ANNOTATED SHEET SHOWING CHANGES

"APPARATUS FOR WIRING BICYCLE ELECTRICAL COMPONENTS"

Application No.: 10/604,932

Fig. 3

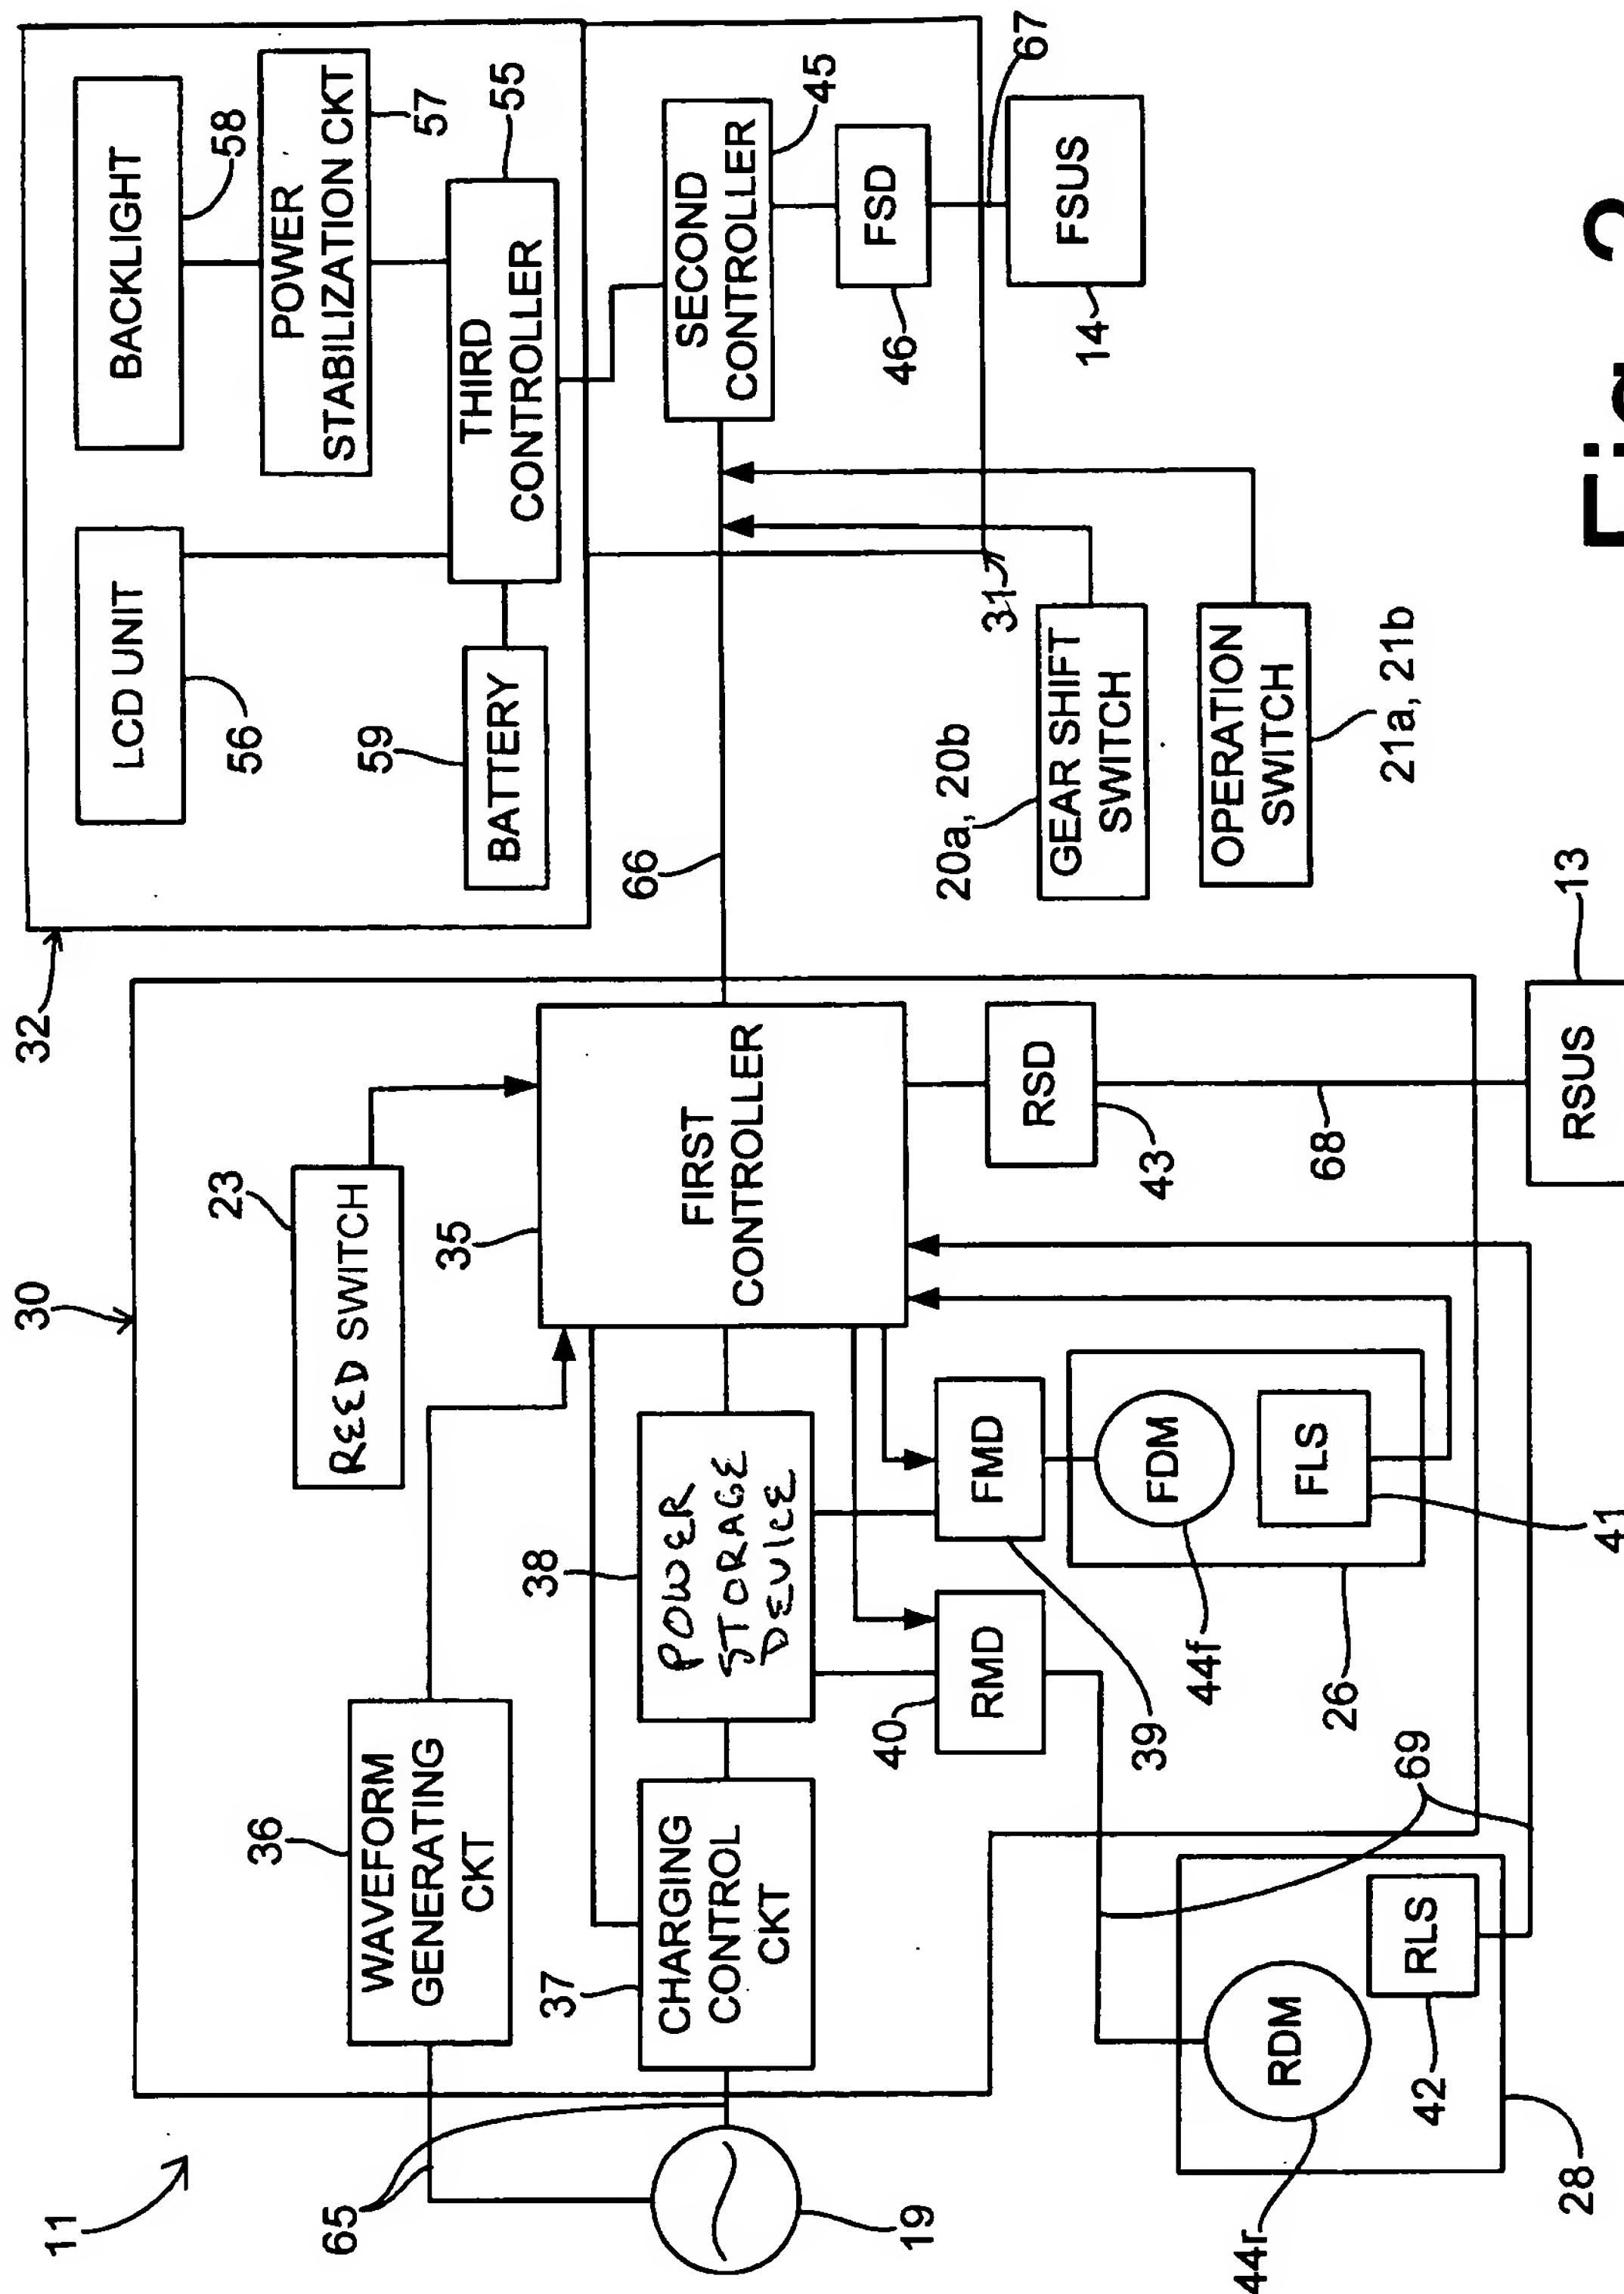
The drawings have been amended to overcome the objections noted by the examiner. More specifically, Fig. 3 has been amended to properly label reed switch 23 and power storage device 23, and Fig. 5 has been amended to properly refer to a display window 80e. The specification has been amended to refer to display window 80e.
